Service Information

Model: Finisher-E1 Ref. No.: FF-T01-W-000092-01

Location: STAPLER

Subject: UPDATING THE SERVICE PARTS

< Parts Configuration in the Past >

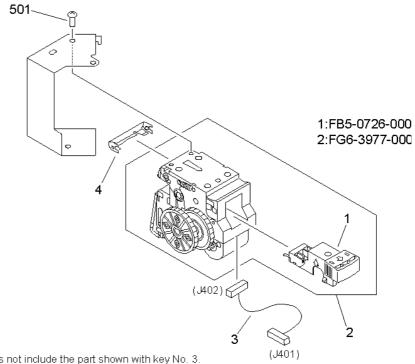
Details : The stapler unit (FB5-0725-000) set up as a service part at present does not include the staple cartridge (FB5-0726-000), and a change has been made so that the unit will contain a staple cartridge; the newly

configured unit will be identified as FG6-3977-000. The change was initiated to eliminate possible

problems in the internal parts caused by vibration occurring during transportation.

< Parts Configuration in the Future >
